ADDENDUM NO. 4

PROJECT NAME: Outdoor Adventure Center
UNL PROJECT NUMBER: C220P001

CONSULTANT: RDG Planning & Design
ADDRESS: 900 Farnam on the Mall, Suite 100, Omaha, NE 68102

DATE OF ISSUANCE: July 11, 2012
DATE OF BID OPENING: July 16, 2012

2011.182.00
 35.01
 SDM-008

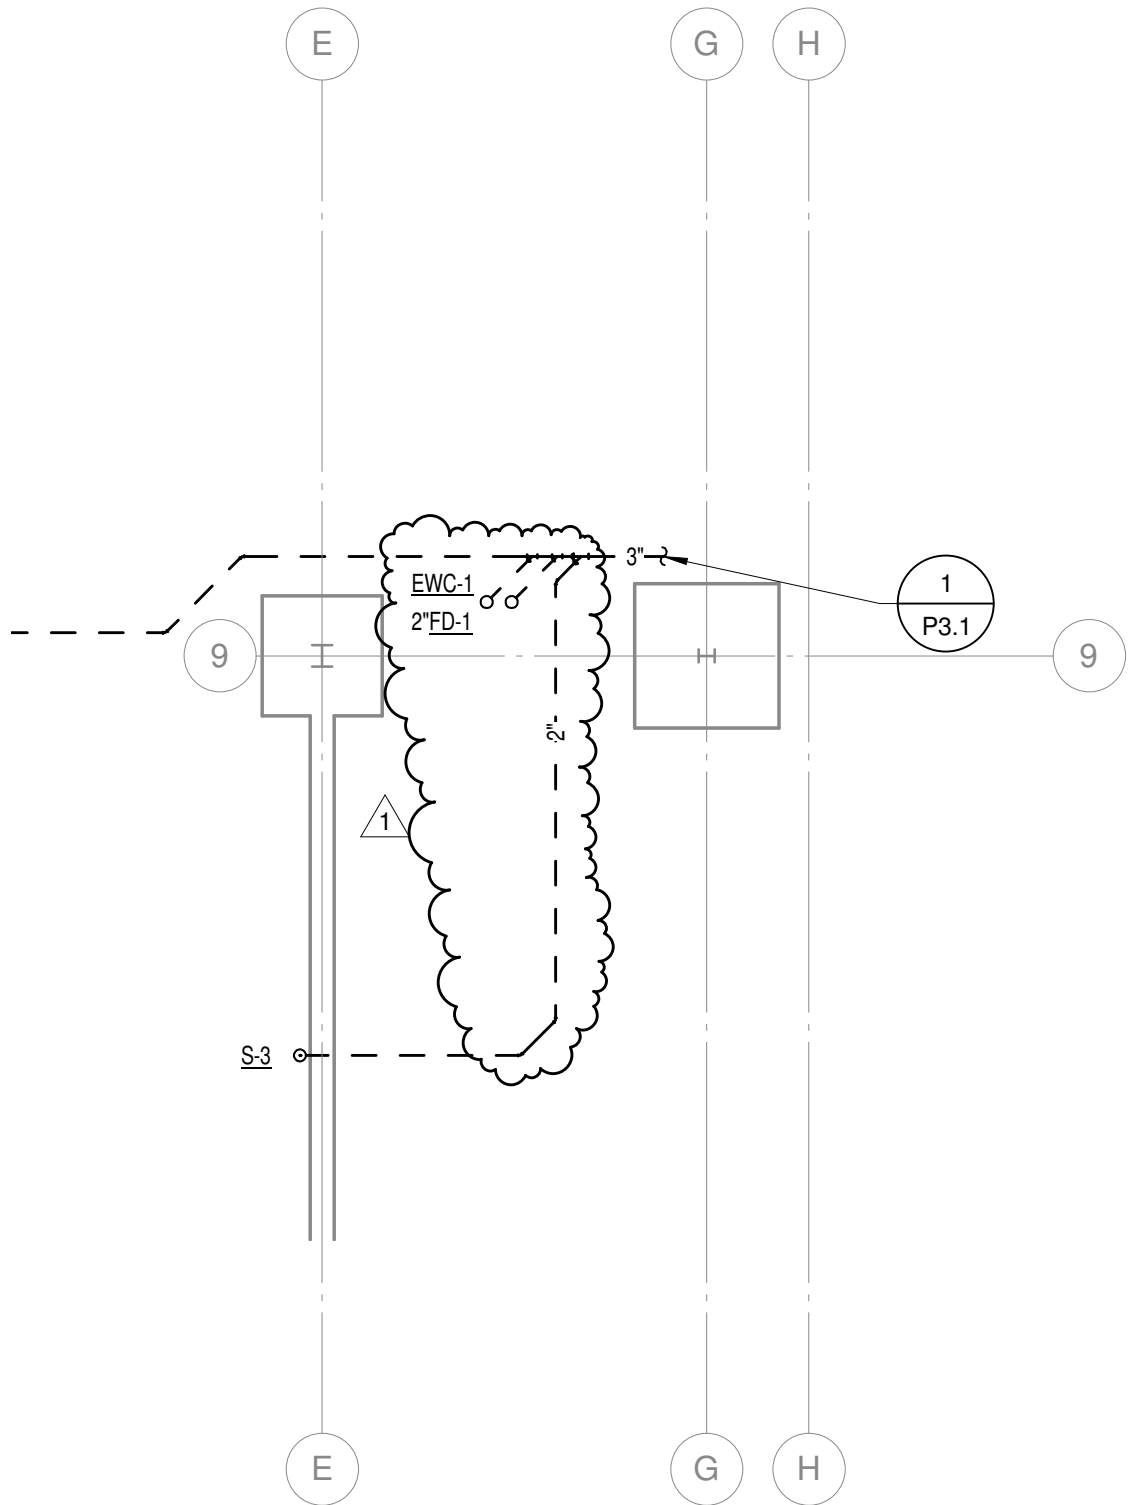
- 4MD-5 Sheet P1.0: Revised sanitary piping for current electric water cooler locations. See attached Supplemental Drawings SDM-008 and SDM-009.
- 4MD-6 Sheet P1.1: Revised water supply and vent piping for current electric water cooler locations. See attached Supplemental Drawings SDM-010 and SDM-011.

2011.182.00
35.01
SDE-008

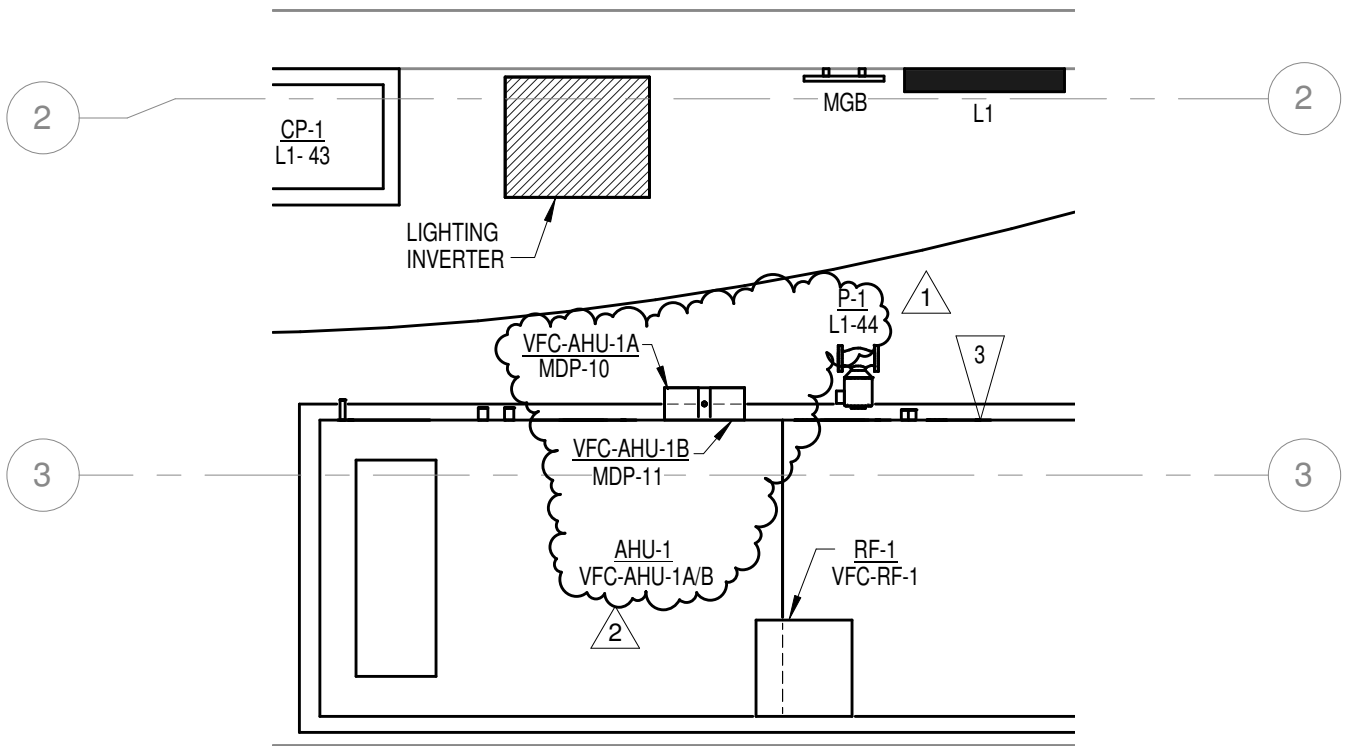
- 4ED-1 Sheet E2.1:
- A. Clarified cable tray conduit size in corridor. See attached Supplemental Drawing SDE-008.
 - B. Modified receptacle location in Climbing Center. See attached Supplemental Drawing SDE-008.
 - C. Clarified circuit numbers for VFC-AHU-2A, VFC-AHU-2B, P-2, and AHU-2. See attached Supplemental Drawing SDE-008.
 - D. Modified receptacle locations for corridor drinking fountain. See attached Supplemental Drawing SDE-008.
- 4ED-2 Sheet E3.1: Clarified circuit numbers for VFC-AHU-1A, VFC-AHU-1B, P-1, and AHU-1. See attached Supplemental Drawing SDE-009.
